REMARKS

This Reply is in response to the Office Action mailed on June 24, 2004 in which Claims 22-40 were rejected. With this Reply, paragraph [0033] of the Specification, Figure 4 and Figure 10 are amended. Claims 22-40 are presented for reconsideration and allowance.

Title: REPLACEABLE ROLLER
BOGIE FOR DOCUMENT
FEEDING APPARATUS
Inventor(s): Glenn Gaarder et al.
Appl. No.: 10/633,126

FIG. 4

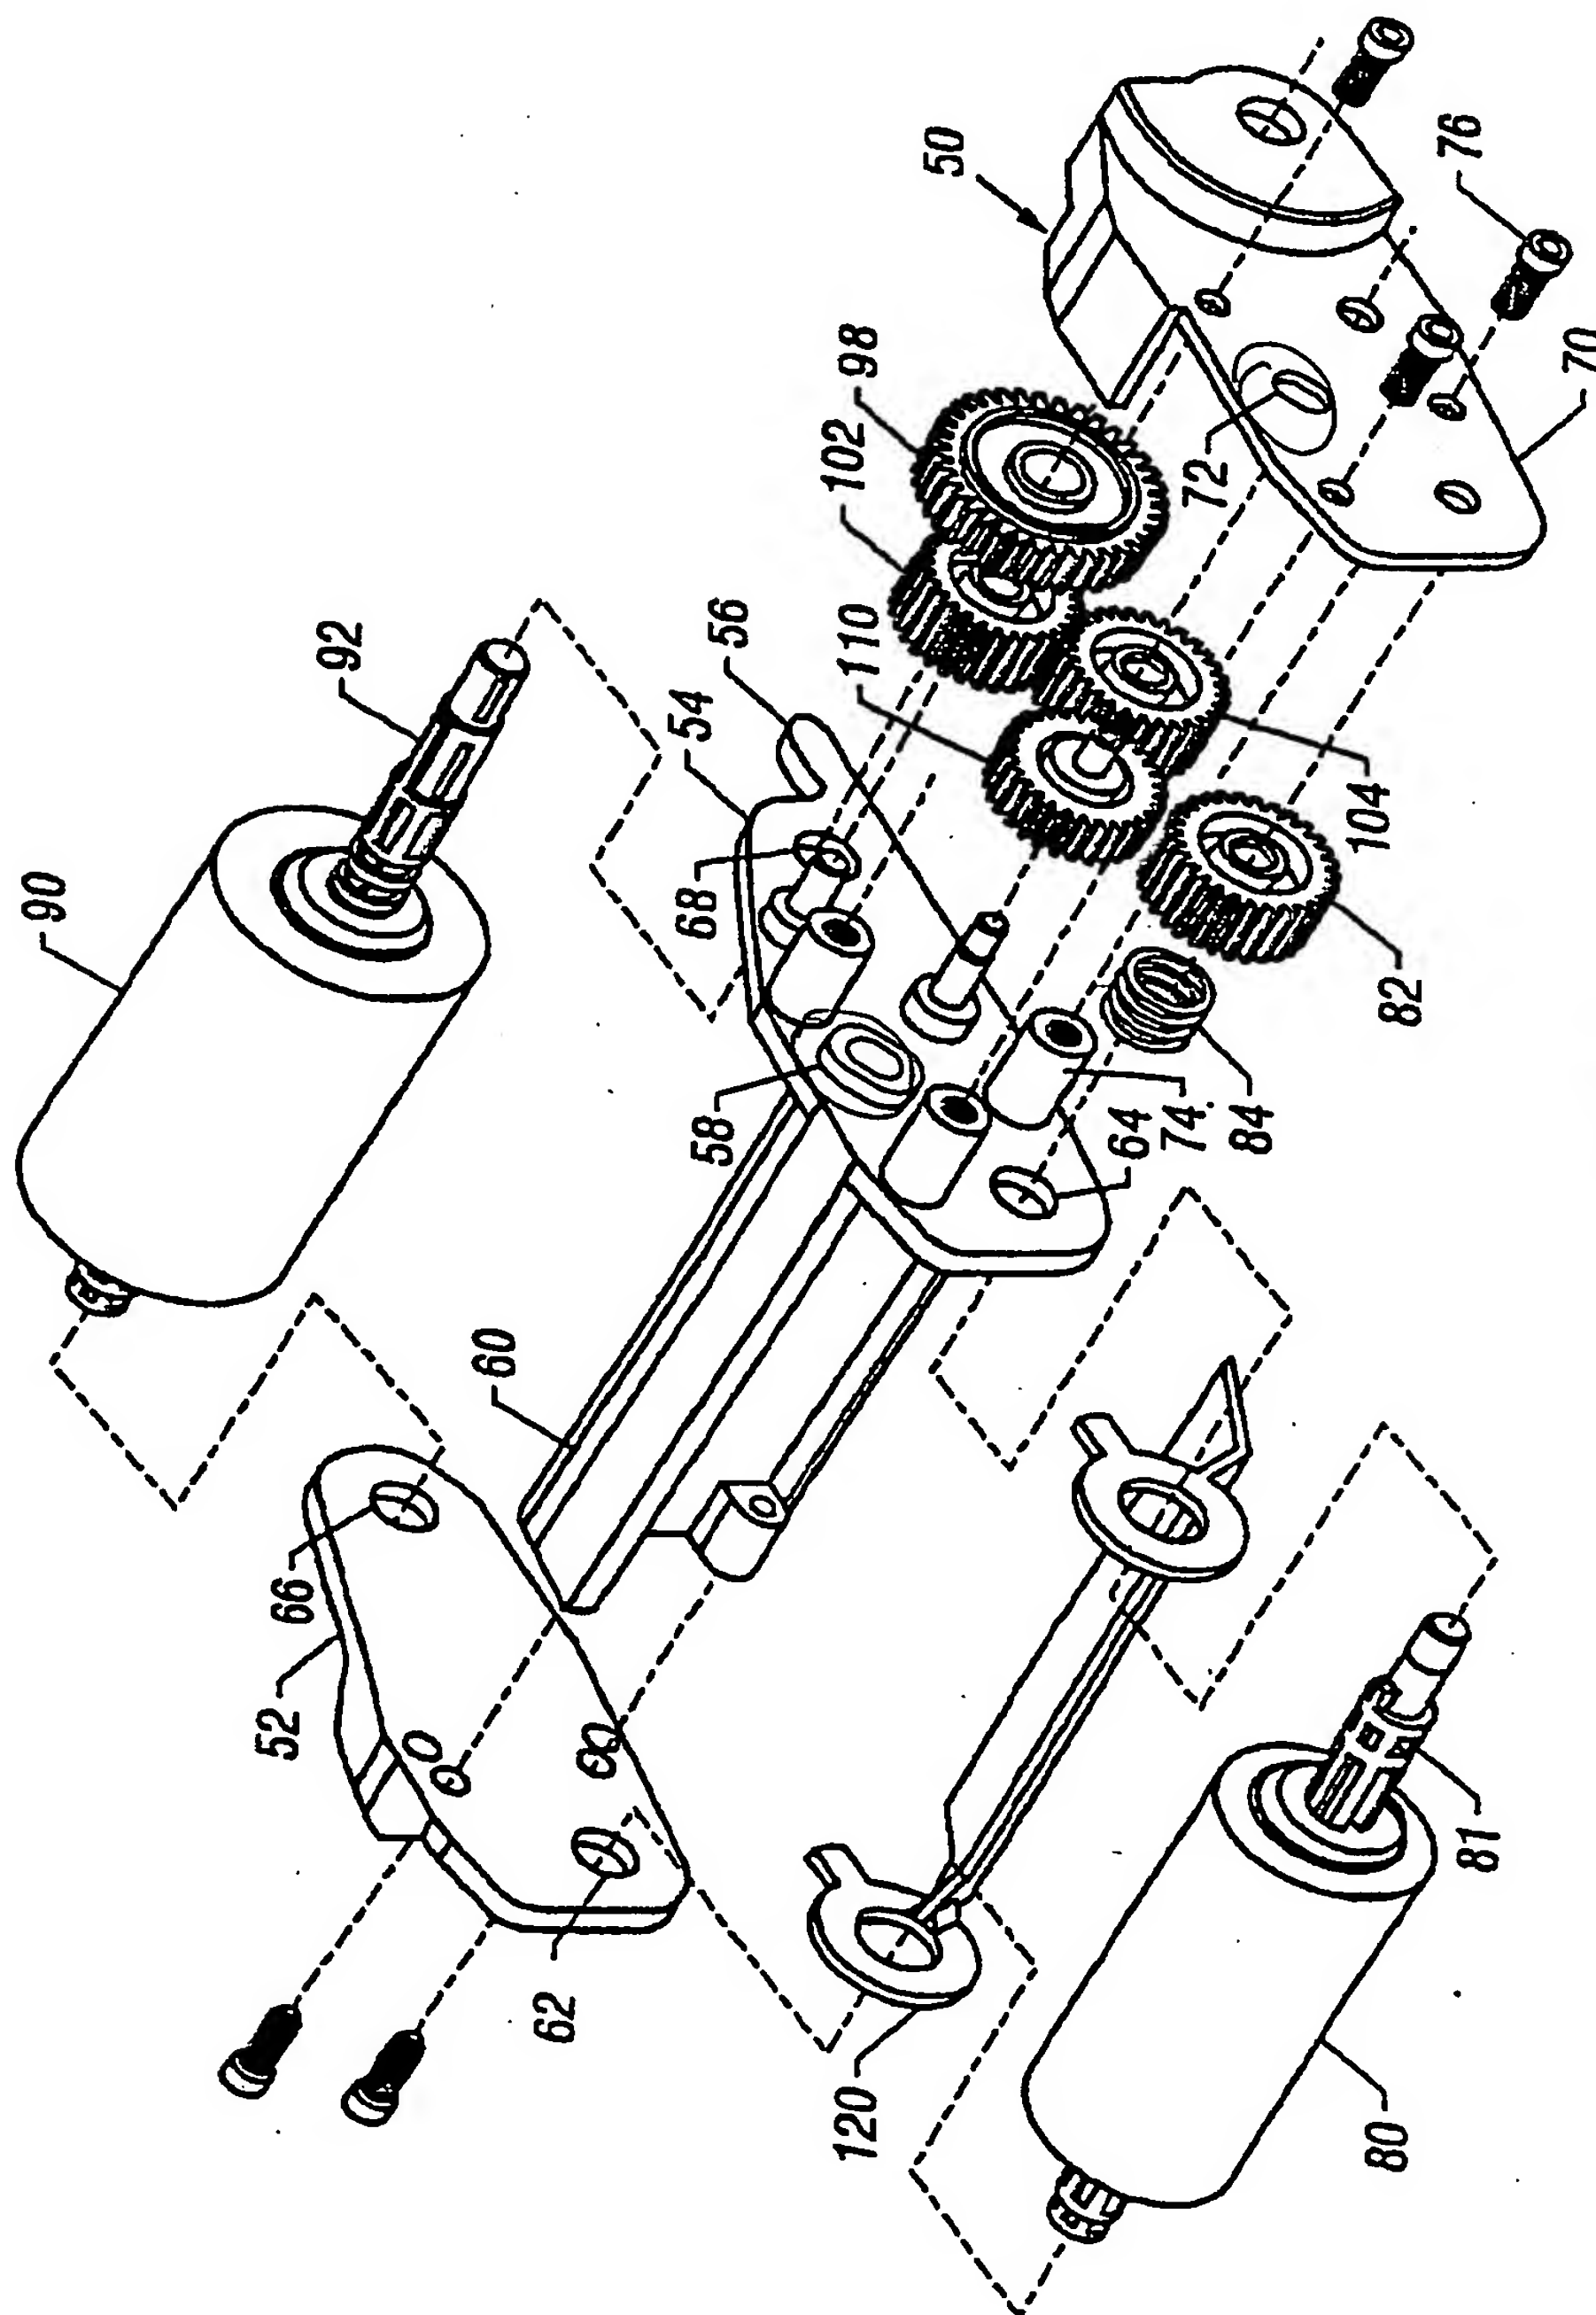
With this Reply, Figure 4 is further amended to correct the angular orientation of slots 58 and 72 as shown in Figure 4 on the attached amended drawing sheet. A replacement sheet including the amended Figure 4 also filed herewith. Support for this amendment is found in Figures 7, 14 and 16A-I through 16-E-3. Thus, no new matter is believed to have been added. In addition, a letter to the official draftsman with annotated drawing sheets of Figures 4 and 10 and replacement sheets of Figures 4 and 10 are also being filed herewith.

Please amend Figures 4 and 10 as indicated in red and circled on the attached annotated drawing sheet. Replacement drawing sheets including Figures 4 and 10 are also being filed herewith.

FIG. 10

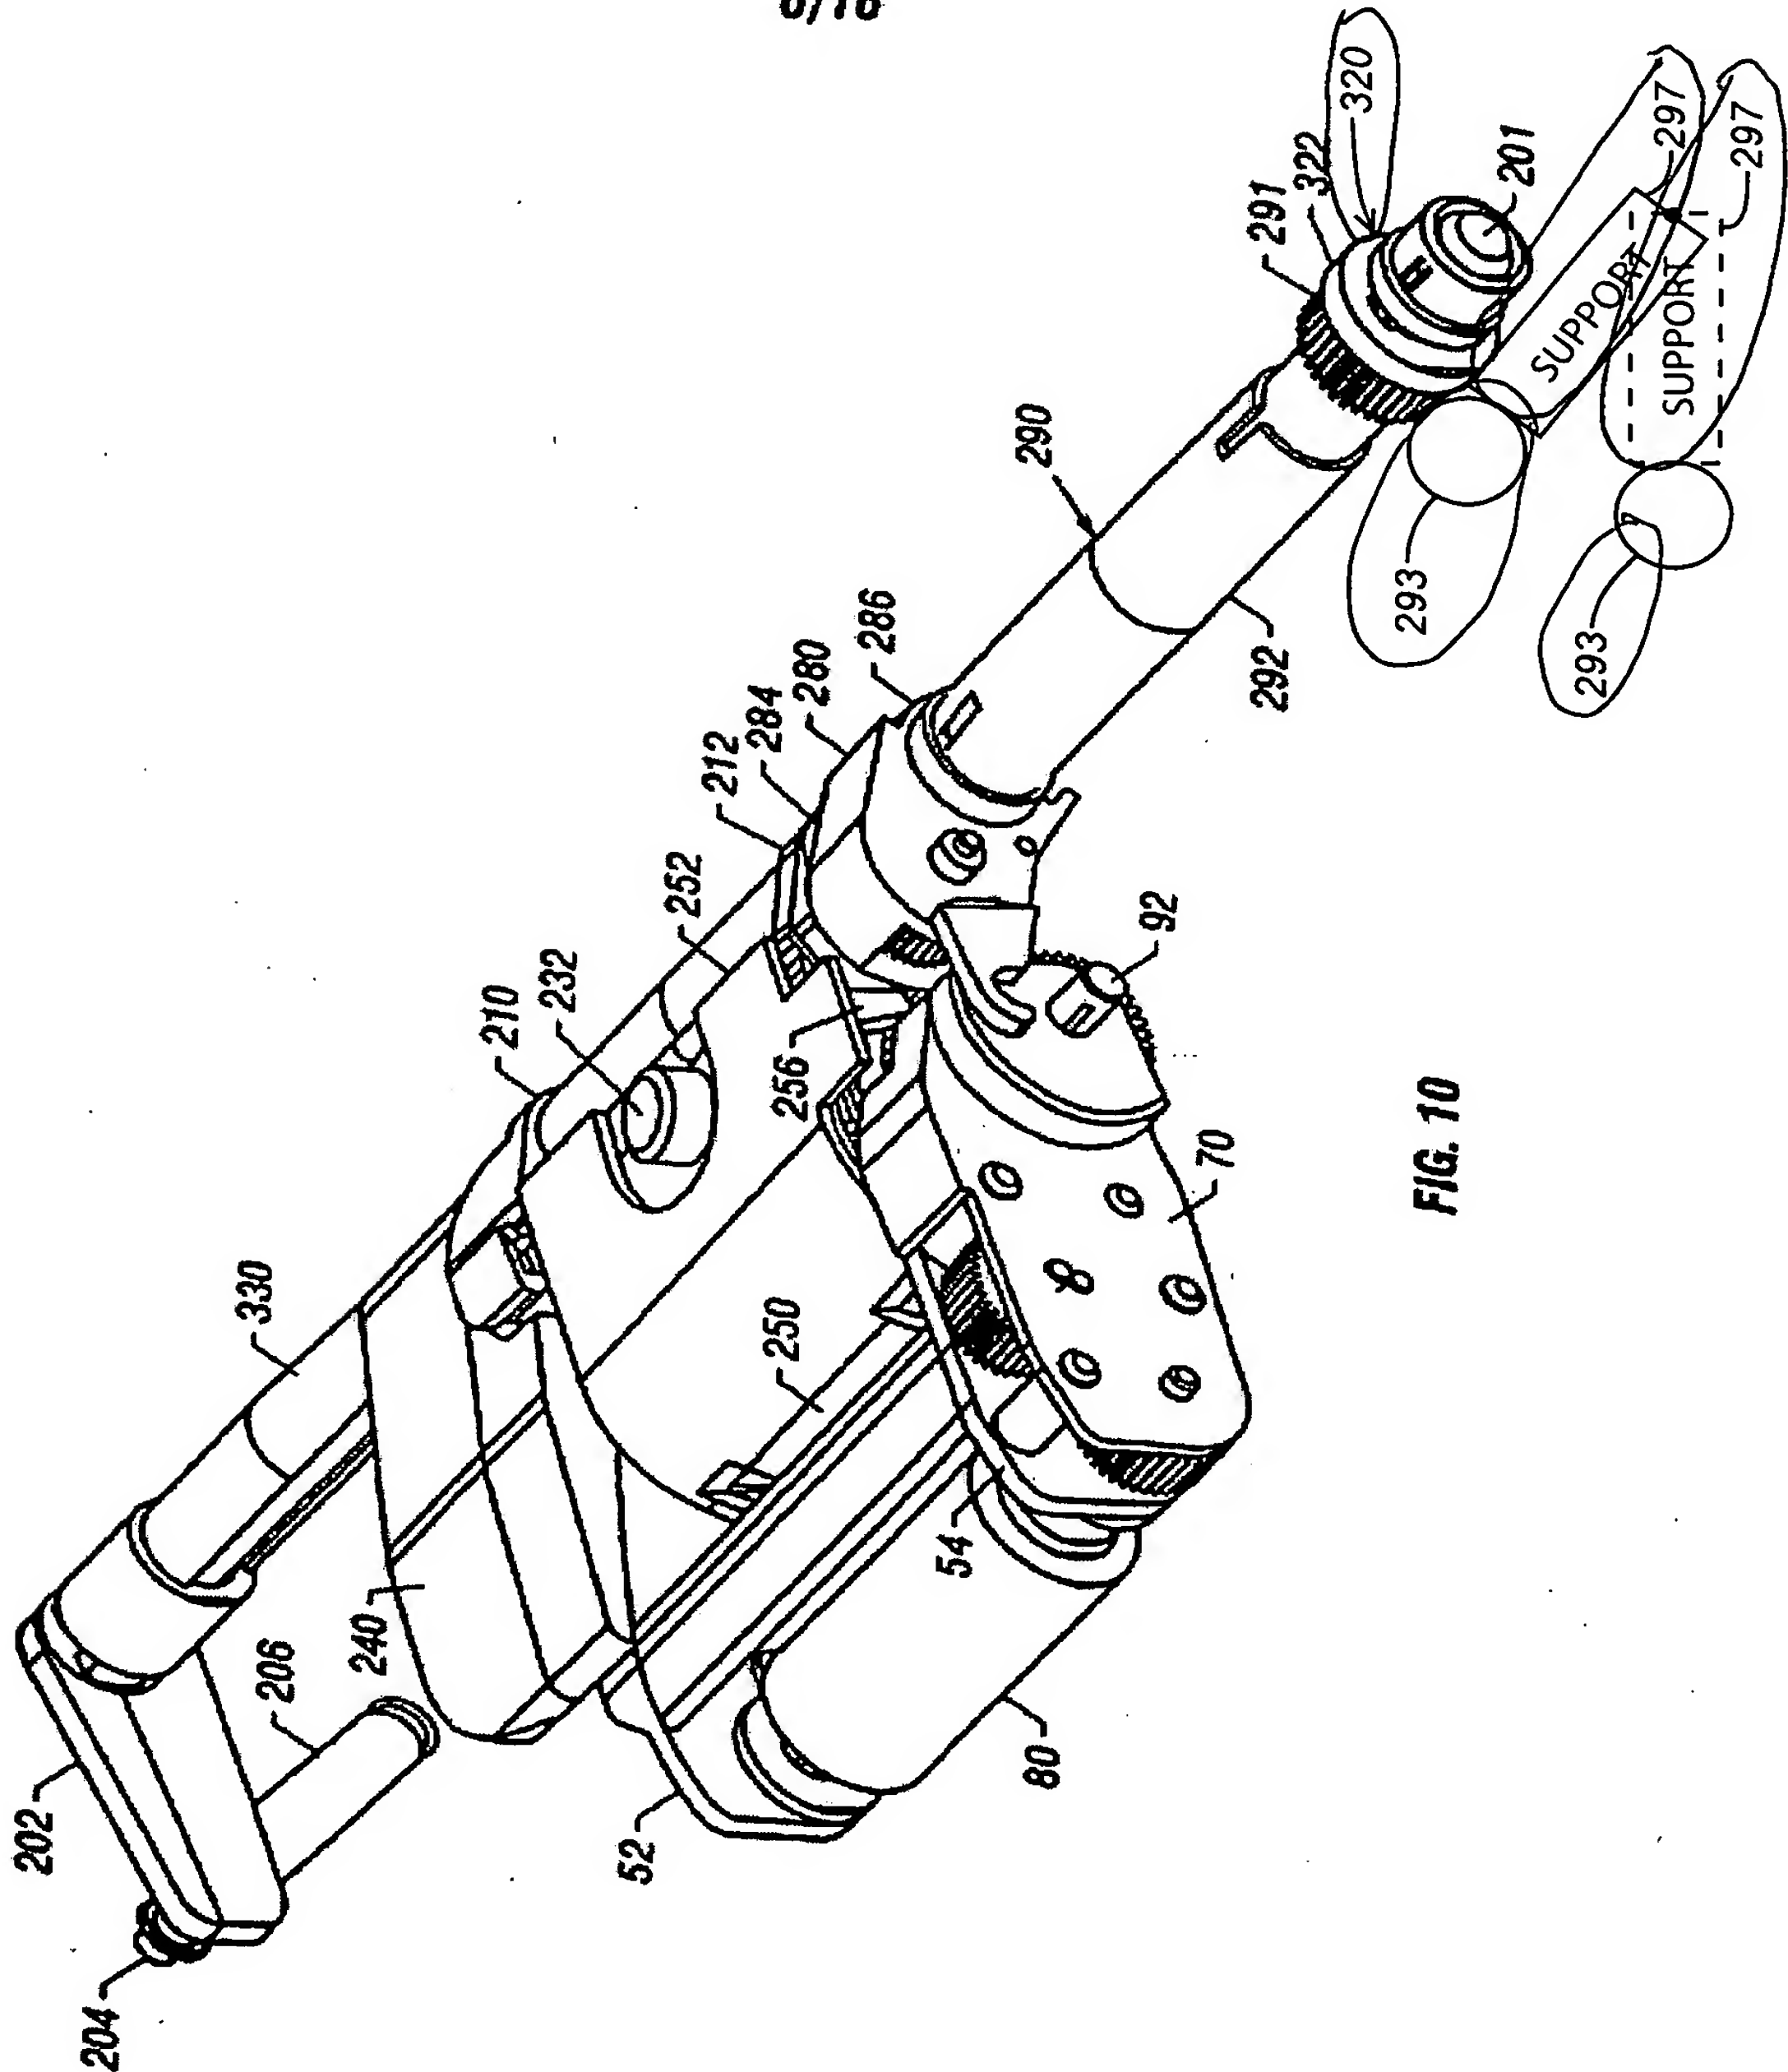
Page 2 of the Office Action objected to the drawings under 37 CFR § 1.83(a). In particular, page 2 of the Office Action requested that the motor-driven output gear and the pivotal motor output gear support be shown or cancelled from the claims. In response, Figure 10 of the drawings is amended to schematically illustrate a motor-driven output gear 293 and the pivotal motor output gear support 297. Figure 10 specifically illustrates pivoting of the support 297 into and out of engagement with surface 322 of retainer 320 such that motor output gear 293 moves into and out of engagement with input gear 291. Applicants respectfully note that one of ordinary skill in the art would understand what a “gear” is. Applicants respectfully note that one of ordinary skill in the art would understand what a “support” for a gear is. In particular, a support for a gear is a member which supports the gear. The claims do not require any specific structure for the support. Rather, the claims merely state that the support engages the cylindrical surface 322 when gear 293 is engaged to gear 291. Figure 10, as amended, illustrates what is described and supported in originally filed paragraph [0033] of the Specification. Accordingly, no new matter is believed to have been added.

Applicants respectfully note that the claimed motion limiter refers to the surface 322 of retainer 320 shown in Figure 10 and described in originally filed paragraph [0033]. Paragraph [0033], as originally filed, recited that:

Page 3 of the Office Action rejected Claims 22, 26 and 39 under 35 U.S.C. § 112, first paragraph. In particular, the Office Action asserted that “From what is contained in the application, one of ordinary skill in the art would not be able to understand how to make a motion limiter with an arcuate surface which engages a pivotal support to prevent over engagement of the teeth of gears.” With this Reply, Figure 10 and paragraph [0033] of the Specification are amended. Figure 10, as amended, illustrates an input gear 291 and an arcuate surface 322 which acts as a motion limiter by engaging a schematically shown output gear support 297 when support 297 is pivoted so as to bring output gear 293 into meshing engagement with

To further clarify where support may be found for the recited “motion limiter” in Claims 22-24, paragraph [0033] of the Specification is amended to recite that the cylindrical surface 322 “acts as a motion limiter by engaging motor output gear support.” Accordingly, Applicants respectfully request that the objection to the specification as failing to provide proper antecedent basis for the subject matter of Claims 22-24 be withdrawn.
